TO: HEARINGS OFFICER

SUBJECT: CONDITIONAL USE / CLASS 3 SITE PLAN REVIEW CASE NO. CU-
SPR21-01
1977 CLAXTER ROAD NE
AMANDA NOS. 20-116228-ZO & 20-116229-RP

Summary: A proposal to construct above-ground storage tanks and associated improvements for an existing petroleum products wholesaler.

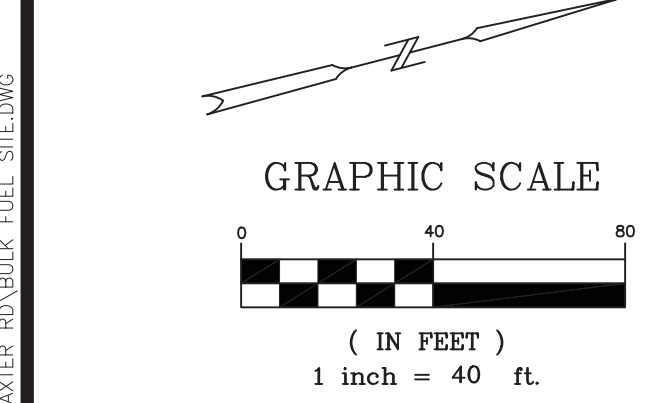
The subject property is approximately 4.93 acres or 214,751 square feet in size. A minimum of 32,213 square feet of the development site shall be landscaped to the Type A standard ($214,751 \times 0.15 = 32,212.7$). The proposed site plan shows approximately 29,407 square feet of the development site as landscaping.

REMOVE TWO VEHICLE PARKING SPACES FOR FOUR BICYCLE SPACES AND ADD TWO NEW VEHICLE PARKING SPACES

Condition 2: A minimum of 15 percent, or approximately 32,213 square feet, of the development site shall be landscaped to the Type A standard.
